Project Name: Delray Commons-Taco Bell

SITE PLAN REVIEW AND APPEARANCE BOARD STAFF REPORT

File No.: 2017-173-
SPI-SPR-CL4

Application Type: Class IV Site Plan, Landscape Plan,
Architectural Elevations and Murals – Taco Bell

TRASH & RECYCLING ENCLOSURE PLAN

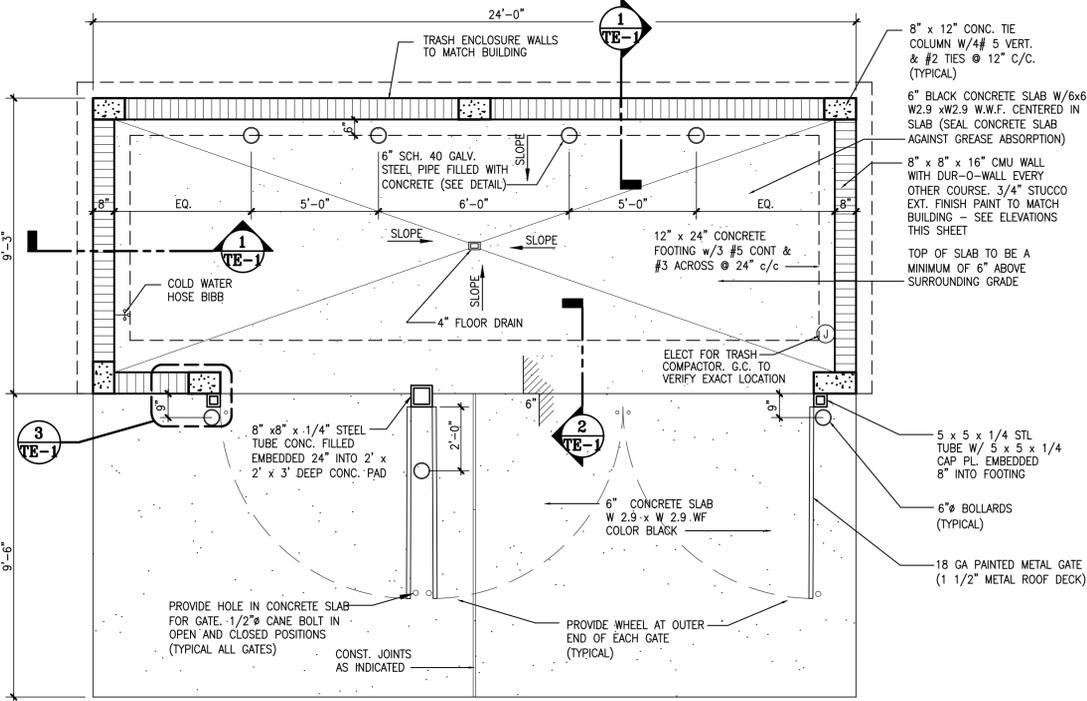
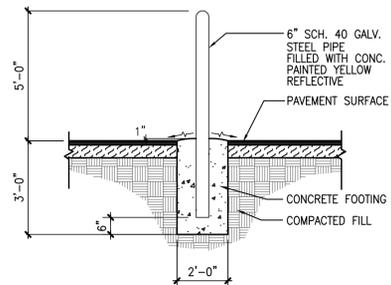
1. Prior to site plan certification, provide a note on the plans that all signage is to be approved by separate permit.
2. Prior to site plan certification provide an updated detail of the refuse enclosure gates as they front a drive aisle. Gates shall be visually compatible with the site architecture.
